Subject: Transmittal of Revision 2 To Service Bulletin Number  
V25000-ENG-73-0169.

# International Aero Engines SERVICE BULLETIN

ENGINE - FUEL AND CONTROL - TO PROVIDE A NEW A5SCN15/T ELECTRONIC ENGINE  
CONTROL (EEC)

V2500-ENG-73-0169

Programming Harness Definition Table 1 and Power Supply Connections Table 2.  
Figure 2

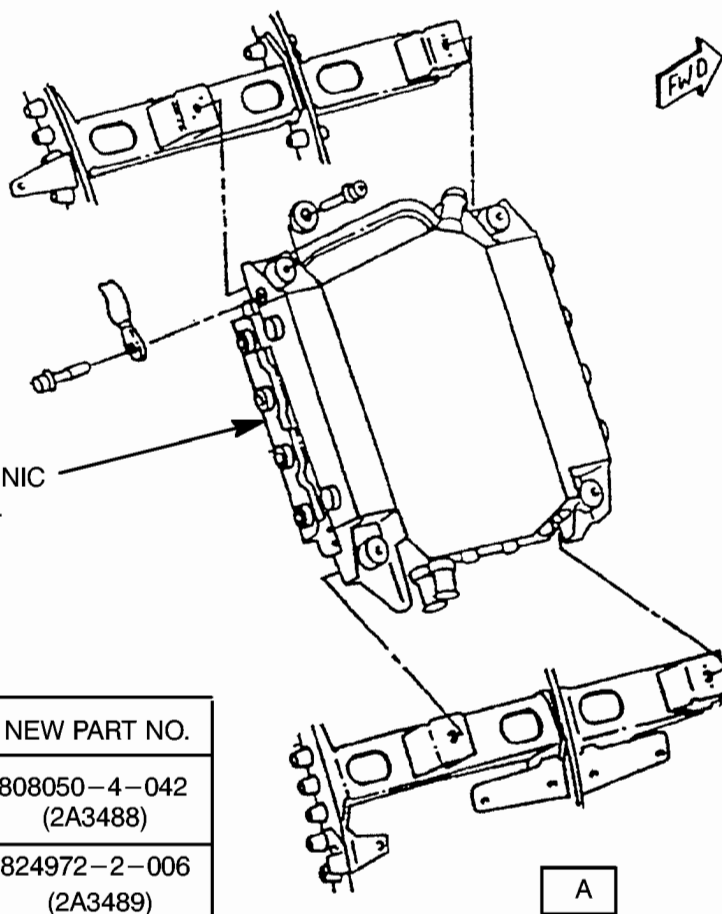
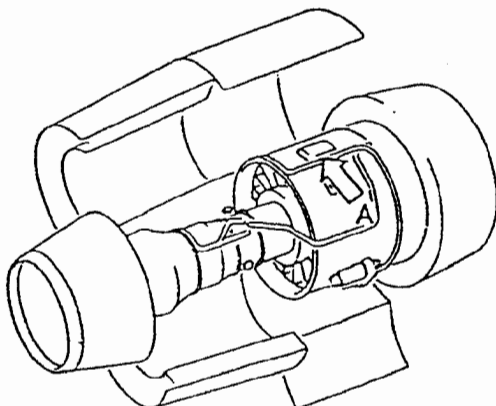
(3) EEC 150-20 Programming Harness Definition as defined in Table 1 (Figure 2).

and wired between BOOT DISC and BOOT/BITE RTN and BITE DISC and BOOT/BITE DISC for each channel. Reference Table 1 (Figure 2) for EEC connector pins.

(6) 28 VDC +/- 0.5A power supply and associated power cables as defined in Table 2 (Figure 2).

Family Tree - Electronic Engine Control (EEC)  
Ref. Catalog Sequence No. 73-22-34. Fig. 01 Item 280  
Figure 4 (Sheet 2)

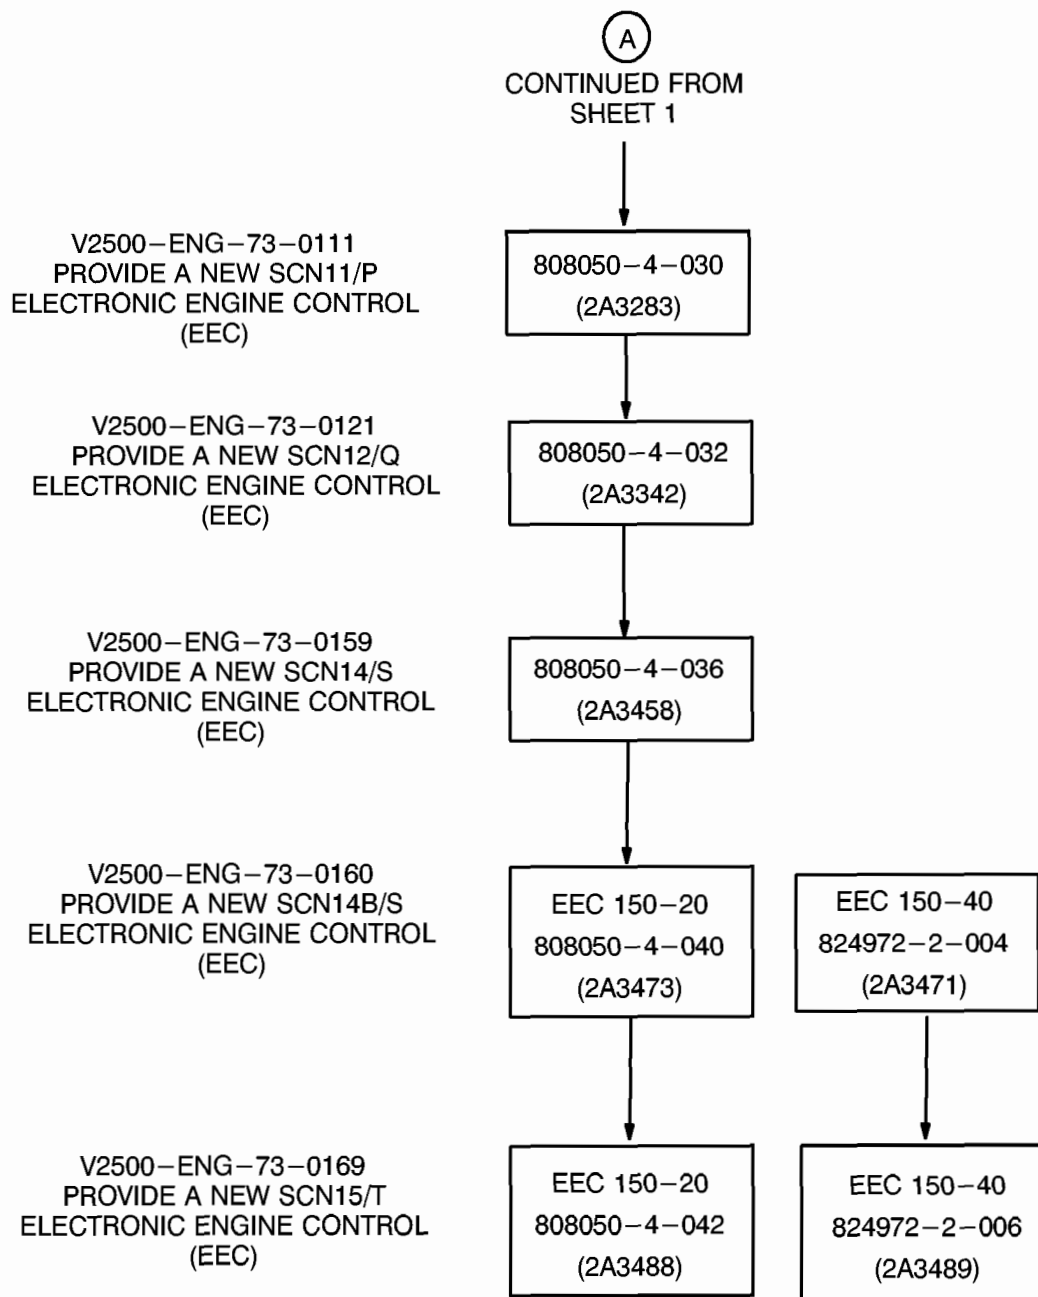
## PART NUMBER CHANGE
